**PIROCCHI RESIDENCE**  
LOT 230, R PLAN 231  
#281 PARKWAY AVENUE  
TOWN OF GEORGINA

Attachment 3  
A08-24 (281 Parkway Ave)  
Page 2 of 18

**Re:** MINOR VARIANCE A08-24  
281 parkway Ave  
Plan 231 Lot 230  
ROLL NO.: 143-679

DRAWING NO.: **GP-1**

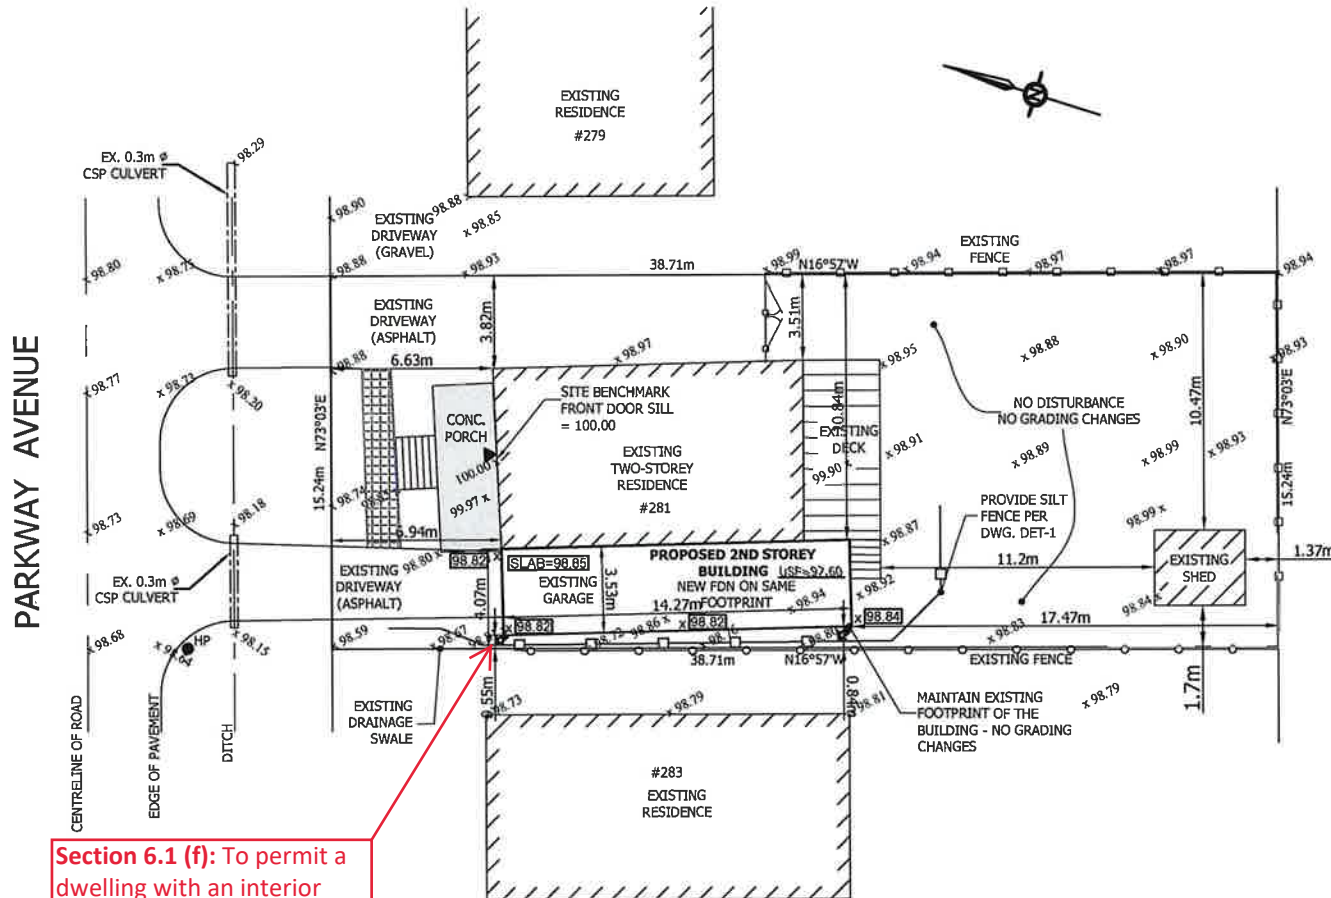
1. The applicant/owner shall provide a detailed lot grading and drainage plan including existing and proposed entrance prepared by a Professional Engineer or Ontario Land Surveyor skilled and competent in such works and all in accordance with the requirements of Part 4 of By-law 2022-0038 (REG-1), as amended. The plan shall show existing conditions including grade elevations of the entire lot, to the satisfaction of the Town's Development Engineering Division.
  - A Professional Engineer is required to prepare drainage plans that contain any LID's (soakaway pit, infiltration gallery, French drain, etc.). Please contact the Development Engineering Division for any questions or concerns.

Title  
**FRONT  
ELEVATION**

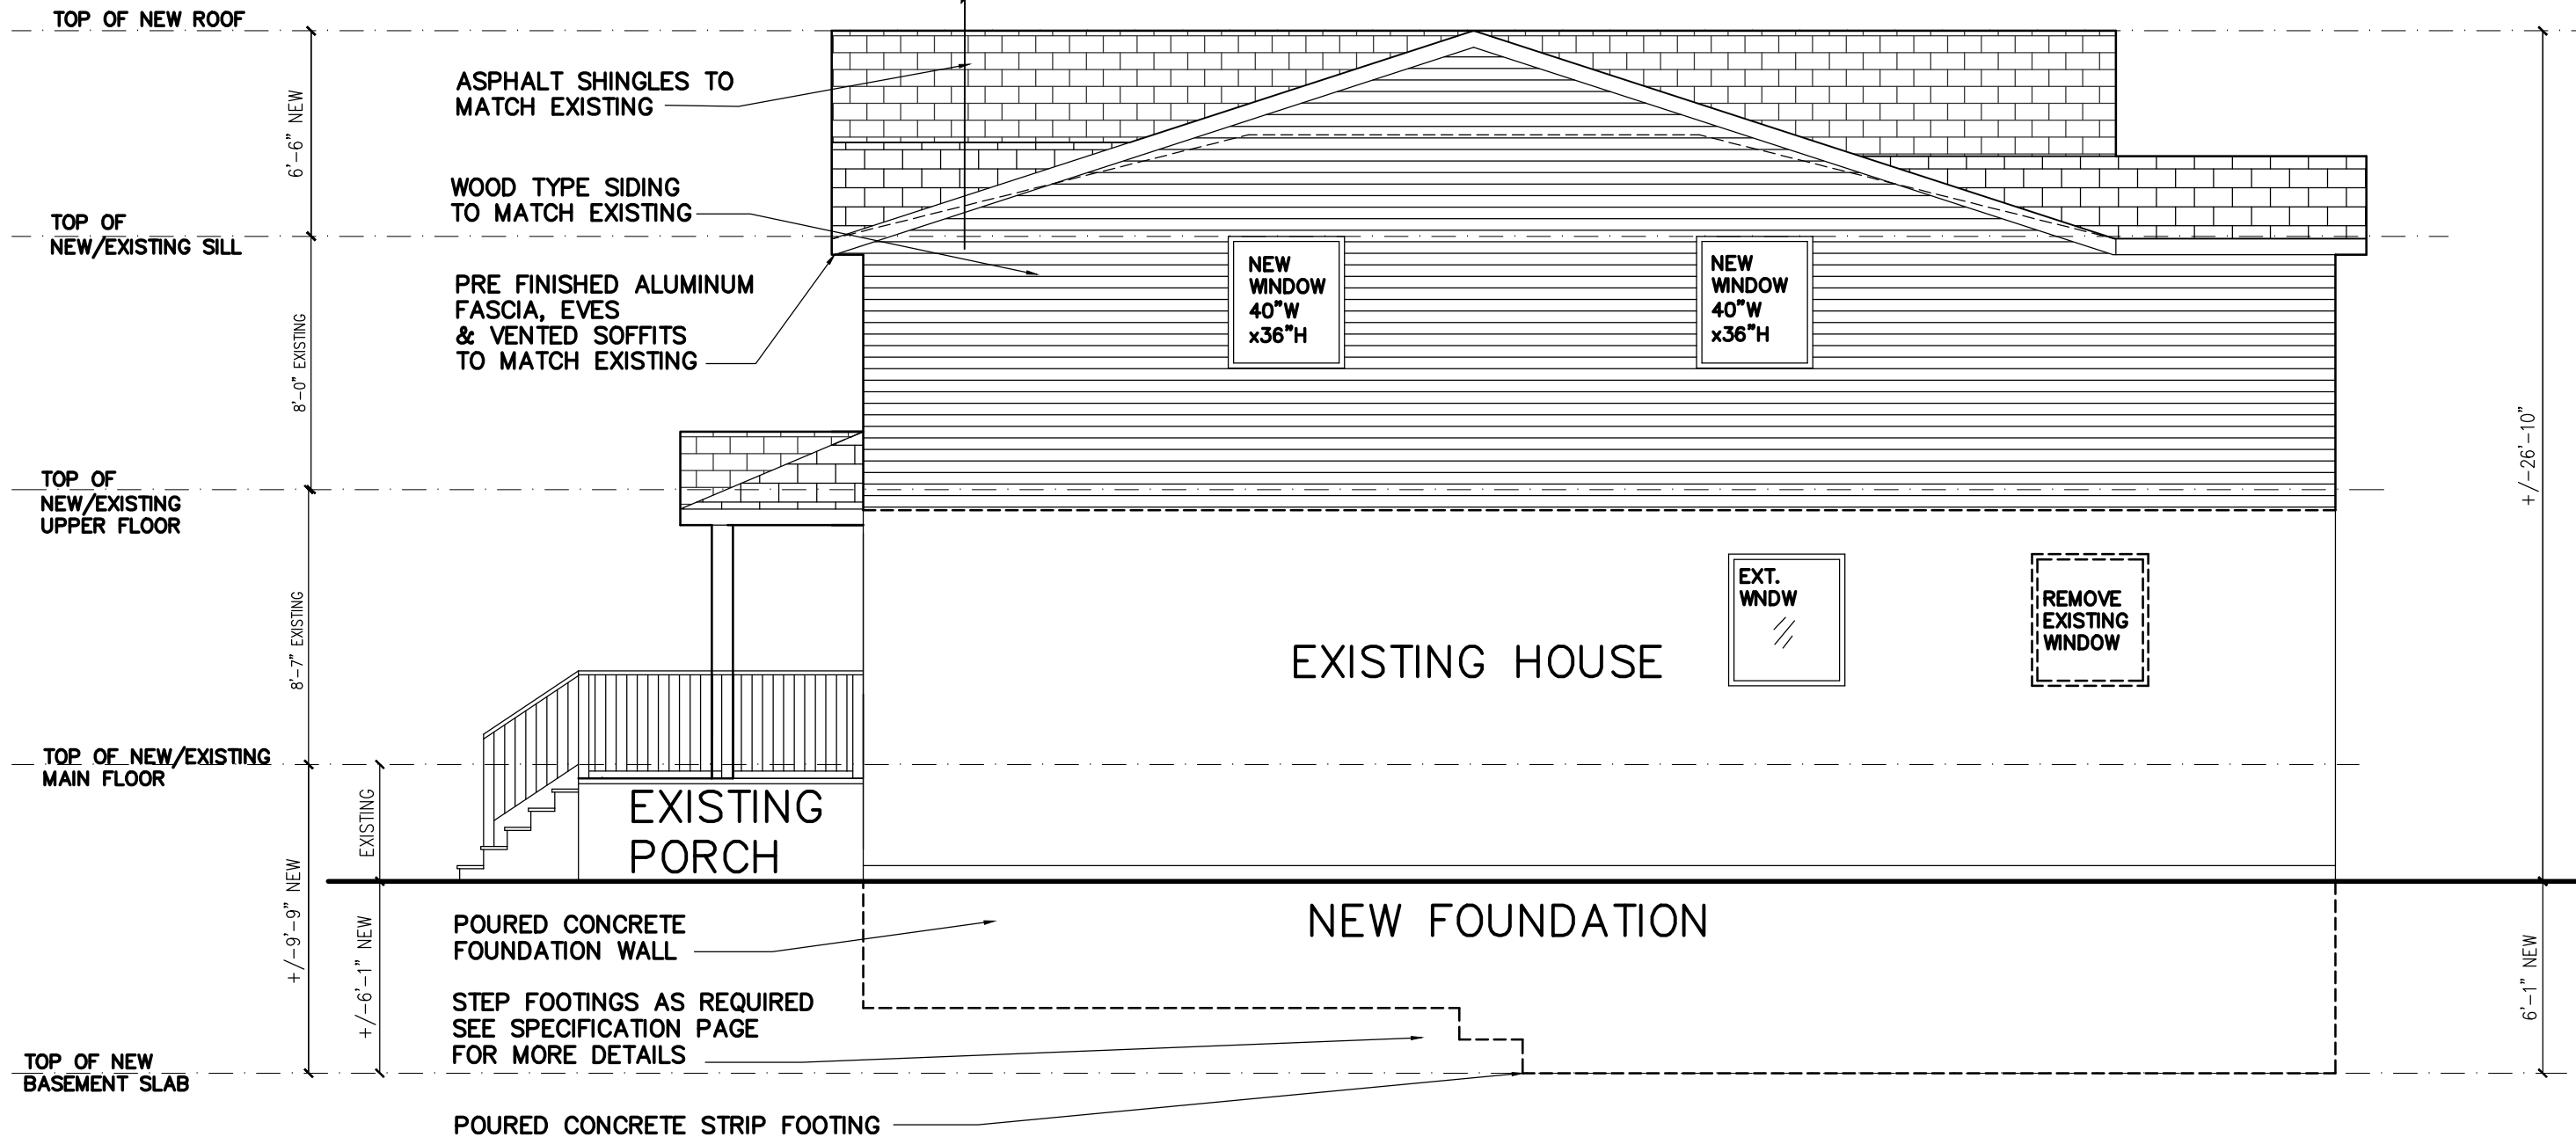
Department/Agency	Date Received	Response:	
Building Division	July 10, 2024	OBC Compliance will be required for limiting distance (setback to property line) at 0.55m non-combustible construction will be required, also no unprotected window openings will be permitted Our records indicate existing was a carport, and therefore all walls will need to be reviewed for current OBC compliance	
Building/Plumbing Inspector			
Clerks Division			
Community Services			
Development Engineering	July 4, 2024	See Attached	
Economic Development	June 24, 2024	No concerns	
Georgina Fire Department			
Municipal Law	June 24, 2024	No comments	
Operations & Infrastructure	July 4, 2024	No comments	
Policy Planning	June 25, 2024	No comments	
Tax & Revenue	June 26, 2024	No tax concerns	
Bell Canada			
Bell Canada			
Canada Post Corporation (CPC)			
Chippewas of Georgina			
C.N. Business Development & Real Estate			
Enbridge Gas			
Hydro One
